XCAP Meeting

Item #3: Discussion: Update from Technical Working Group Regarding Review of New Ideas/Iterations with Volunteer Civil Engineers and AECOM

To: Expanded Community Advisory Panel (XCAP)
From: Nadia Naik, Chair
Date: December 12, 2019
Subject: Notes and Update from Technical Working Group Regarding Review of New Ideas/Iterations with Volunteer Civil Engineers and AECOM
Agenda Item: This relates to Agenda Item #3 on the December 18 XCAP Agenda

Subject: "New Ideas" from XCAP Technical Working Group

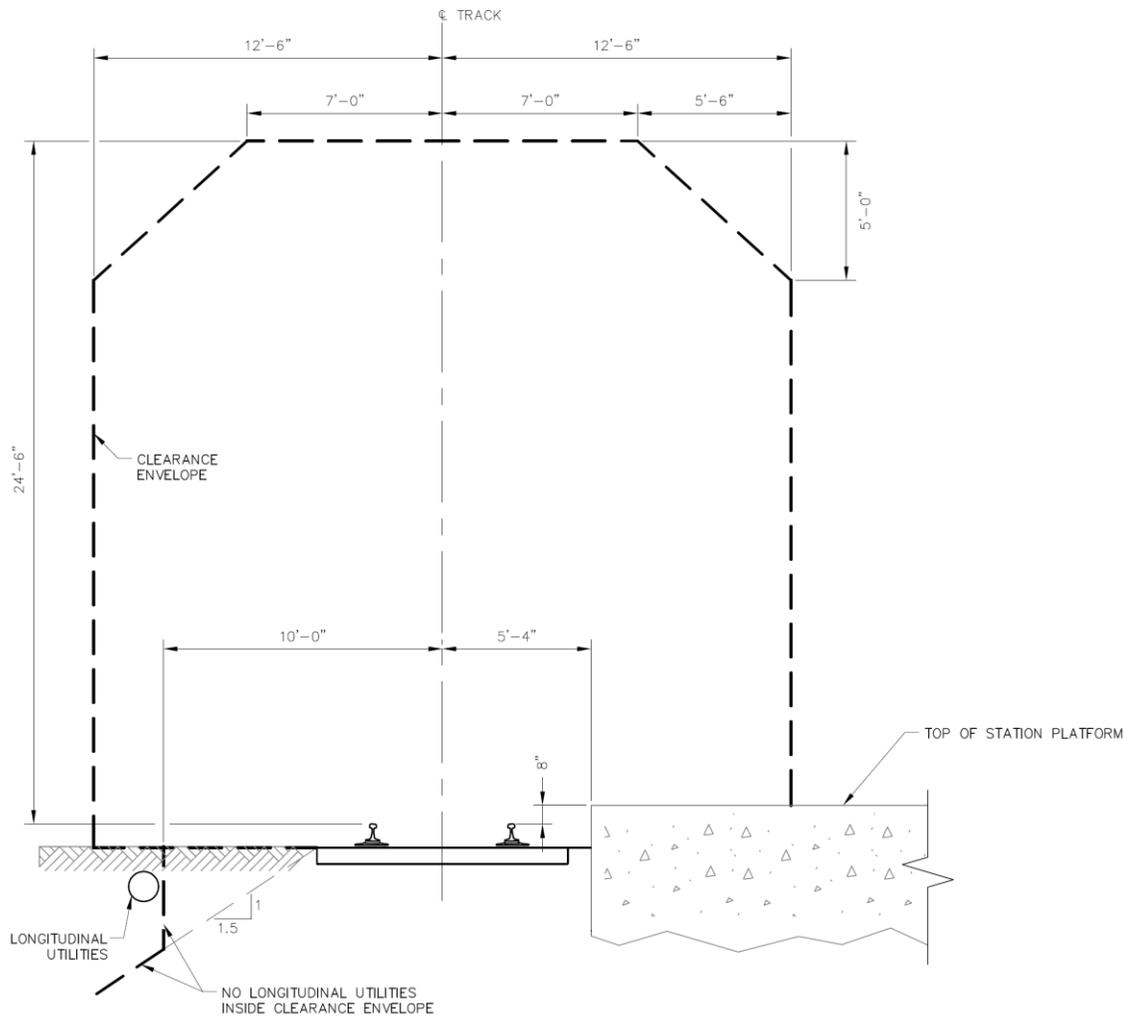
The vertical curve issue is the length of the transition between a level grade and a grade of 1% or 2%, as examples. According to the attached document, Palo Alto Design Criteria, Caltrain uses different formulas to calculate the vertical curve transition for passenger and freight trains. The attached spreadsheet, Vertical Curve calculations.xlsx, shows the required transition lengths for passenger trains at 110 mph and freight trains at 50 mph. Note that for a 2% grade, the required transition length is 578' for passenger trains and 1075' for freight trains, almost twice the length required for passenger trains.

At a freight train design speed between 35 and 40 mph, the required freight train transition length would be the same as for passenger trains at 110 mph. While 50 mph may be a reasonable design speed for fast, high-value freight trains operating for long distances, the freight service on the Peninsula is "local" traffic of mostly low-value bulk commodities with some container traffic, and a reasonable lower speed through Palo Alto would not create a big impact on overall running times. It is not even clear that current Union Pacific freight trains even operate over 35 or 40 mph on Caltrain tracks. Temporary or permanent speed restrictions due to local conditions are common on the US rail network.

The issue here is that all the alternatives under consideration, for all three grade crossings, require vertical curve transitions. If the transitions can be shortened to the passenger train length, there could be considerable construction savings. In addition, shoofly track lengths could be shortened. For the South Palo Alto tunnel, it is possible (but I have not verified) that a revised design might avoid the creeks, especially in combination with a smaller tunnel inner diameter

see p. 5 for vertical curves - differences
between pax and frt.

Figure 5 - Caltrain OCS Clearances

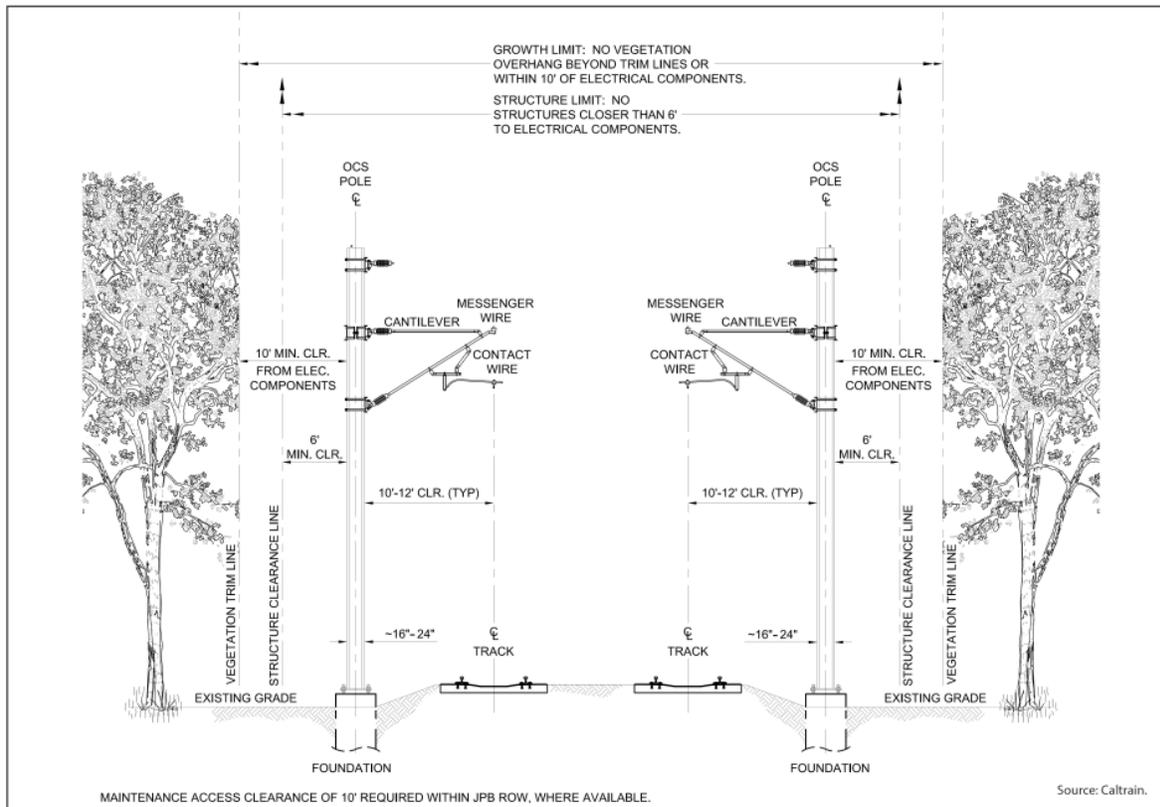
The vertical clearance issue is much harder to pin down because I have not been able to find a single source for this design standard for the spacing between top of rail and the overhead contact wire for power distribution.

I have created a document, Design Standards for Vertical Clearances for Caltrain Electrification, to summarize what I have been able to learn about vertical clearance standards. Clearly the CPUC standard of 34' is not controlling.

In the absence of a Plate H requirement, Caltrain would effectively be operating according to Plate B, a maximum of 15’ 1”. 15’ is also the approximate height of the EMUs that Caltrain is planning to order for electrified service. (need verification of this point). Plate B is sufficient for the hopper and container cars that constitute freight service on Caltrain tracks. Even Plate F may be overdesign for freight train operation on Caltrain tracks.

A 5’ reduction in vertical clearance would result in construction cost savings for the Meadow/Charleston trench alternative, and for the South Palo Alto tunnel alternatives due to a potentially smaller tunnel diameter. Further, for all alternatives, the poles needed to support the catenary structure that holds the overhead power contact wire could be lower, with cost and visual impacts.
